**ADDENDUM NO. 1 - TO
SPECIFICATIONS AND CONTRACT DOCUMENTS
LEWISBURG ELEMENTARY SCHOOL
AND
LEWISBURG PRIMARY SCHOOL
CLASSROOM EXPANSION
DESOTO COUNTY, MISSISSIPPI
FOR
DESOTO COUNTY SCHOOLS**

JANUARY 12, 2017

This addendum forms a part of the Contract Documents and modifies the original specifications and drawings, dated 12-6-16 as noted below. Acknowledge receipt of this Addendum in the space provided on the Bid Form. Failure to do so may subject Bidder to disqualification.

A1.1

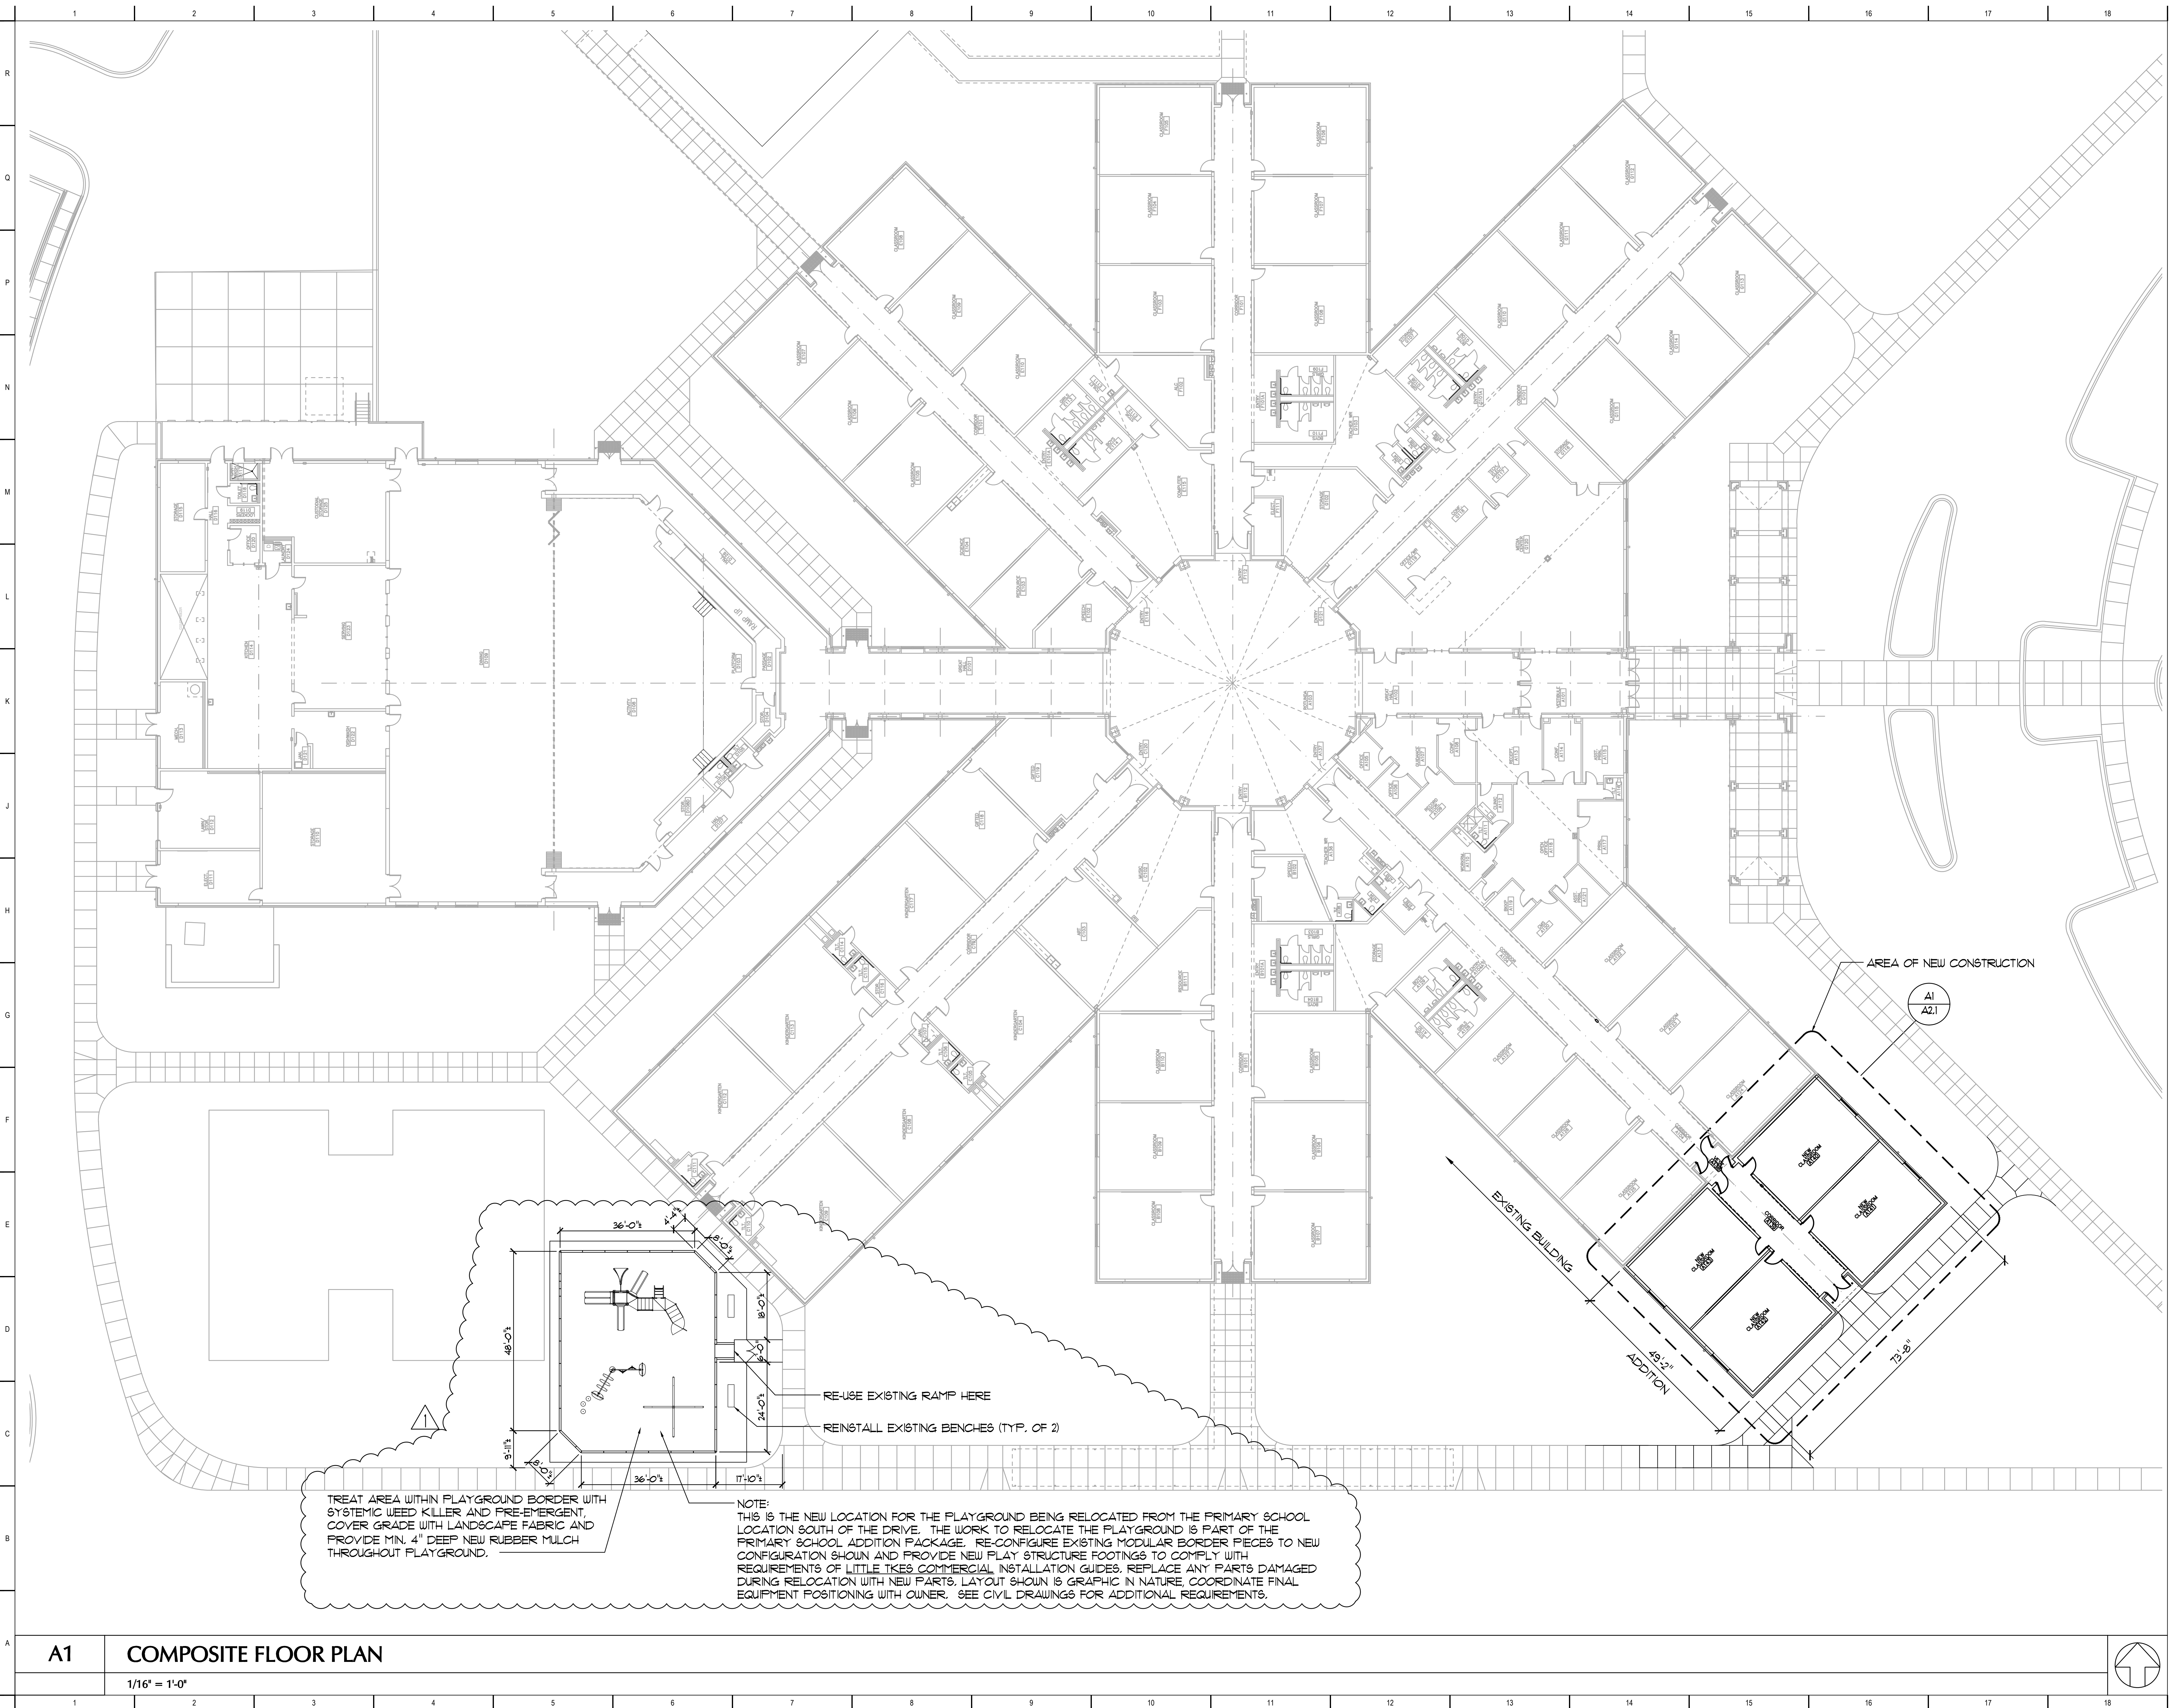
- Item No. 5: DRAWINGS, SHEET A1.1 – COMPOSITE FLOOR PLAN: Remove and destroy this sheet and insert the attached revised Sheet A1.1 – COMPOSITE FLOOR PLAN dated 1-12-17.

S2.00

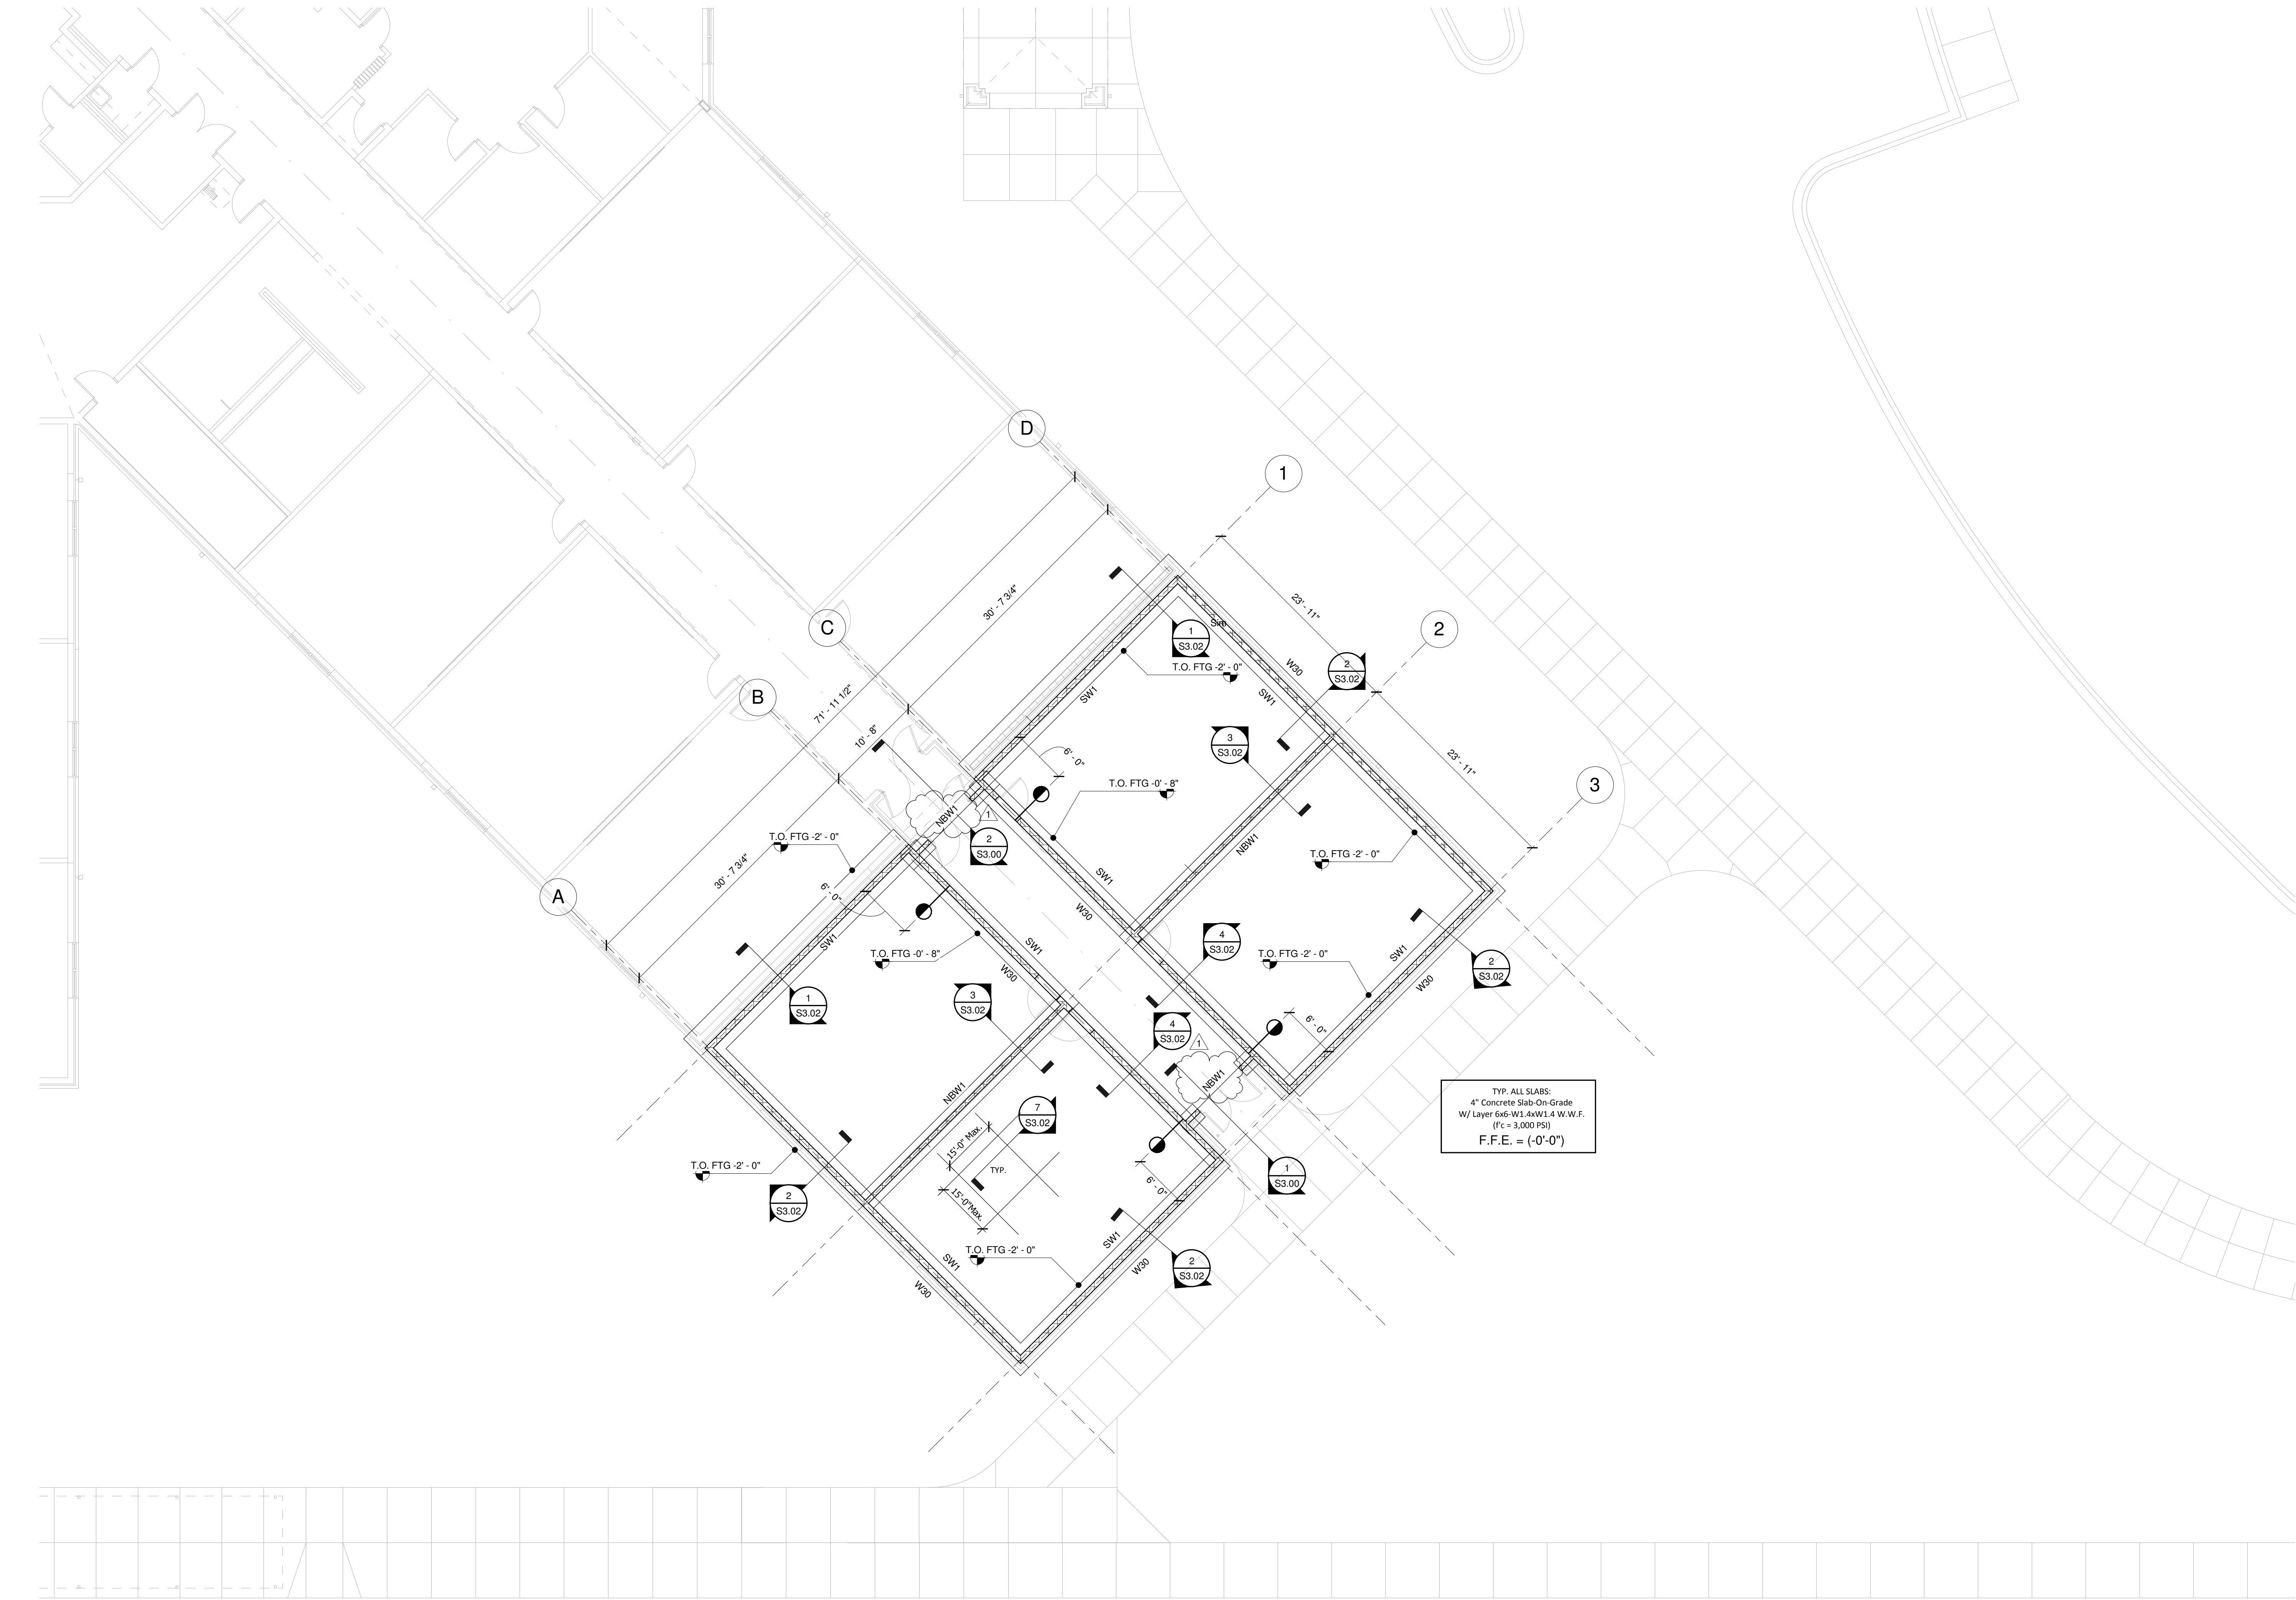
- Item No. 1: DRAWINGS, SHEET 0.0 – INDEX OF DRAWINGS: Remove and destroy this sheet and insert the attached revised Sheet 0.0 - INDEX OF DRAWINGS dated 1-12-17.
- Item No. 2: DRAWINGS, SHEET S2.00 – FOUNDATION PLAN: Remove and destroy this sheet and insert the attached revised Sheet S2.00 – FOUNDATION PLAN dated 1-12-17.

FOUNDATION PLAN

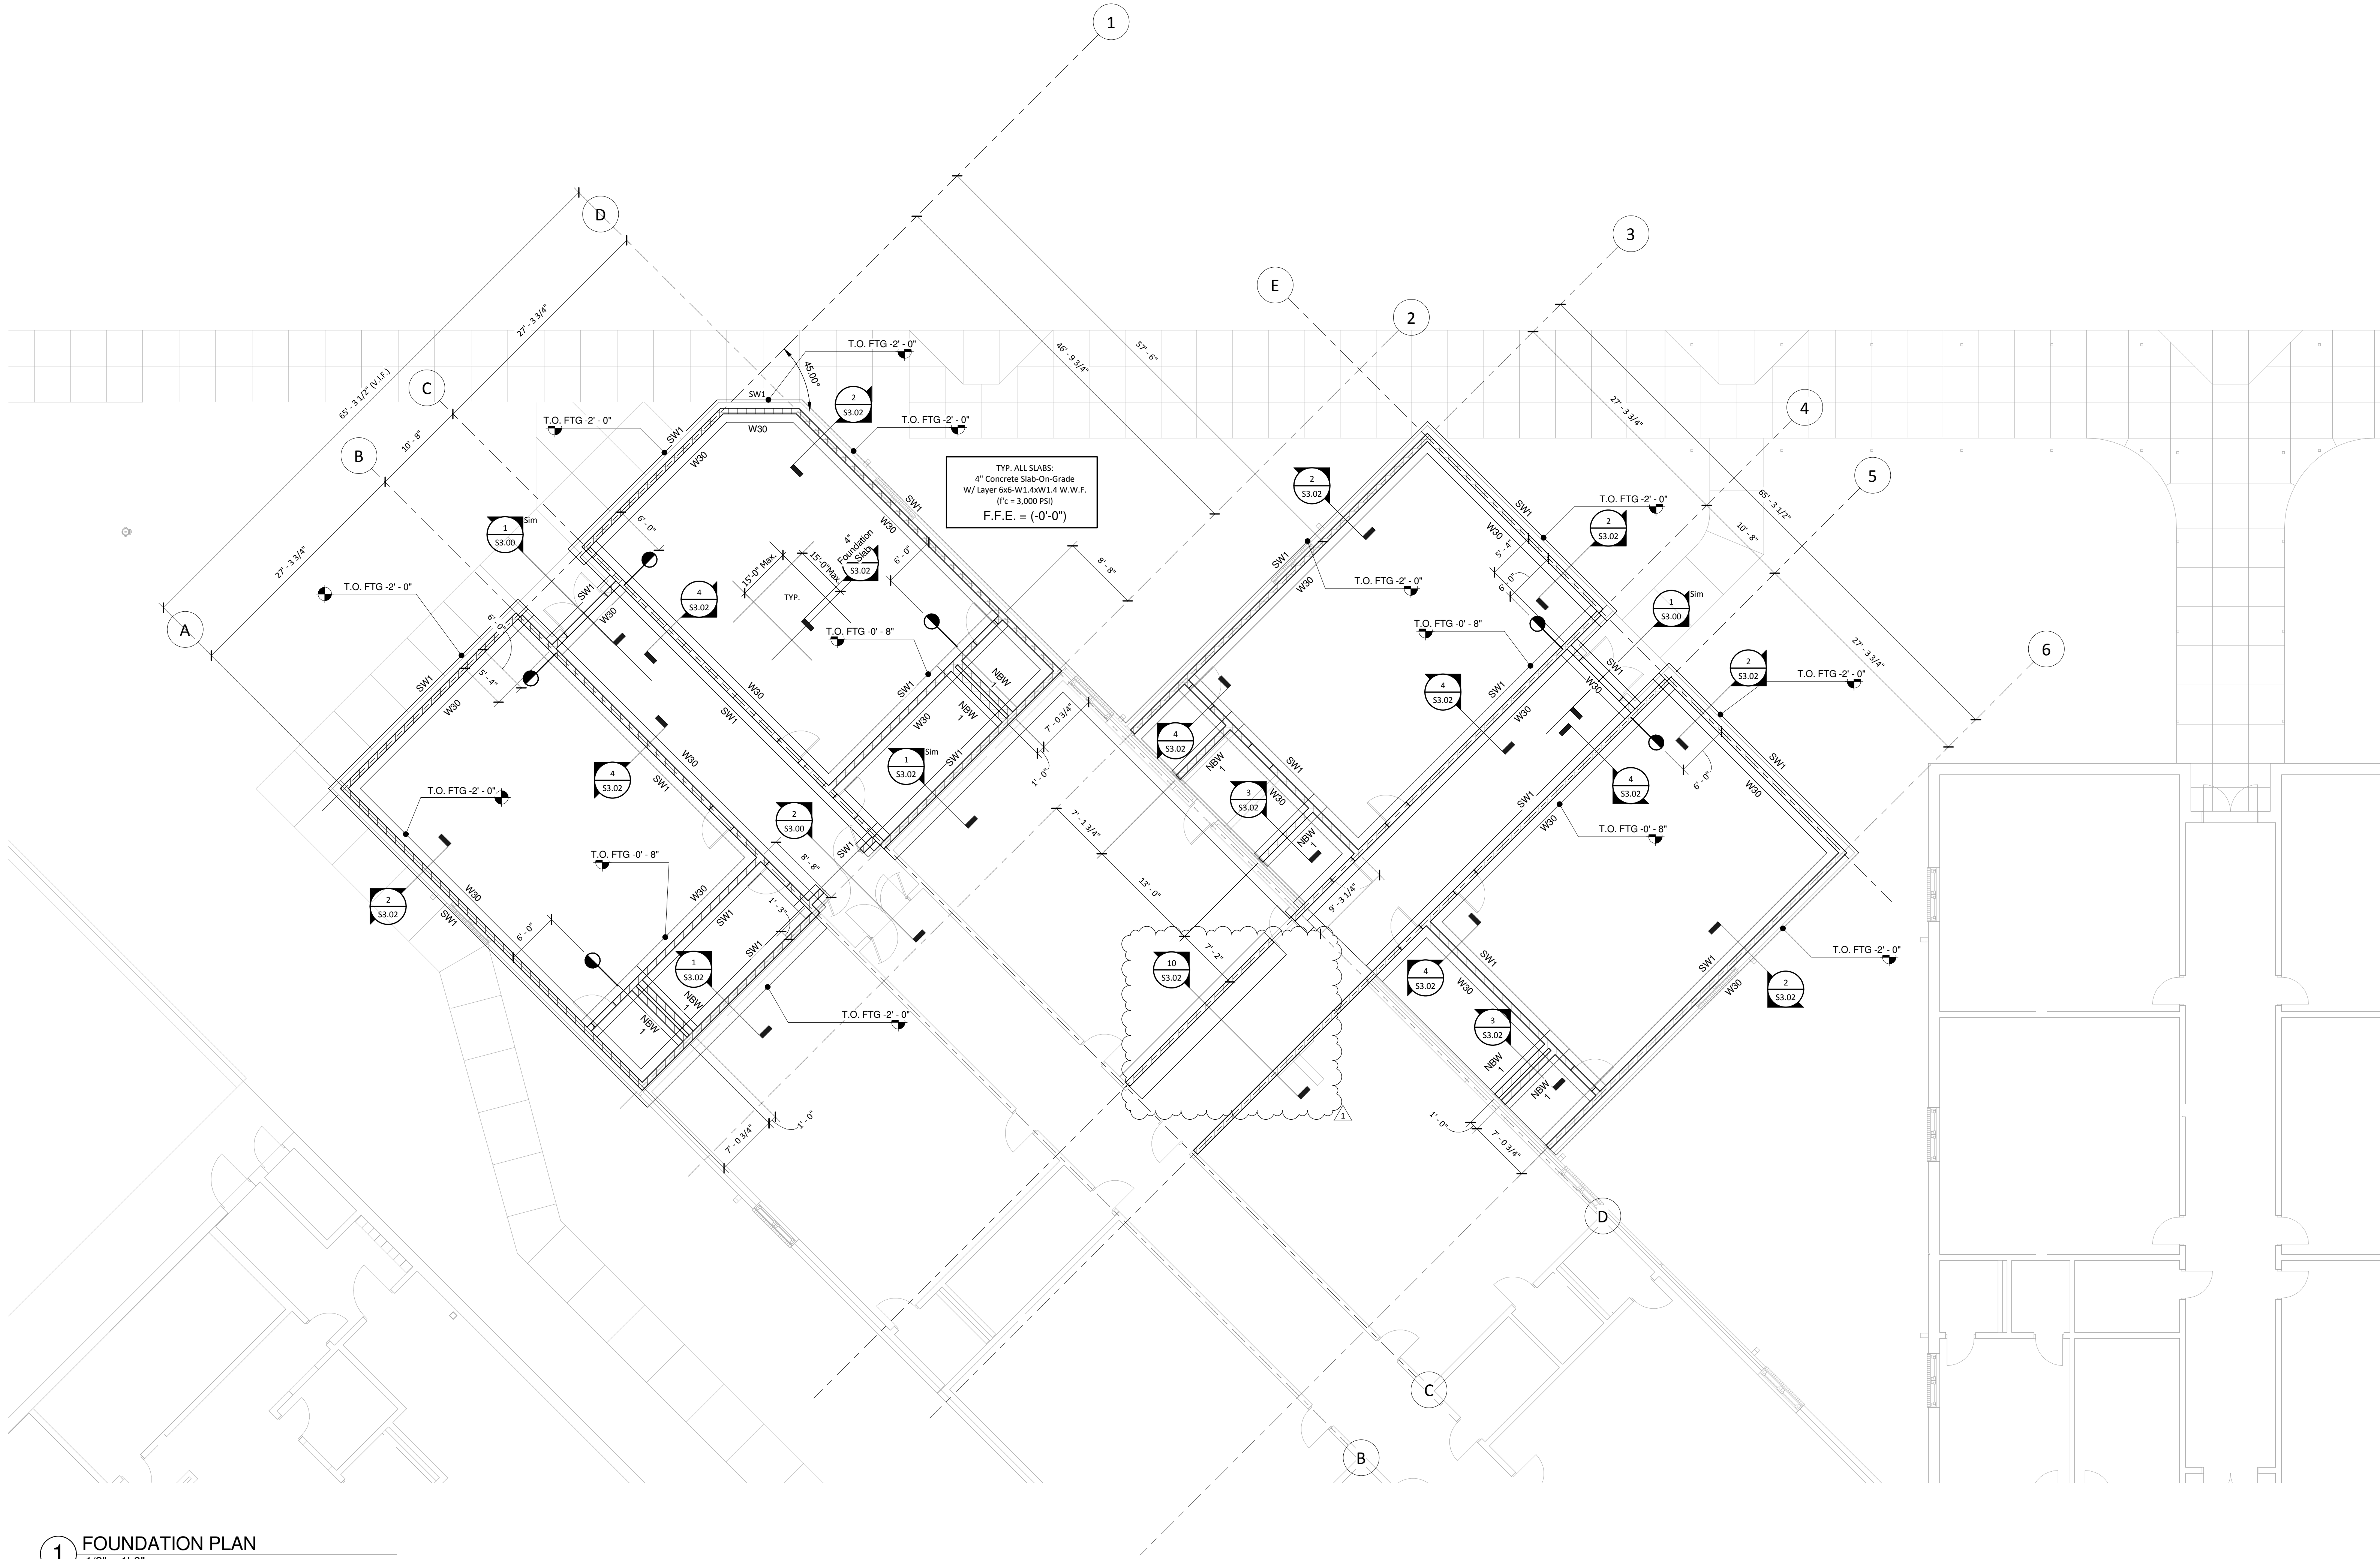
- Item No. 17: DRAWINGS, SHEET S2.00 – FOUNDATION PLAN: Remove and destroy this sheet and insert the attached revised Sheet S2.00 – FOUNDATION PLAN dated 1-12-17.
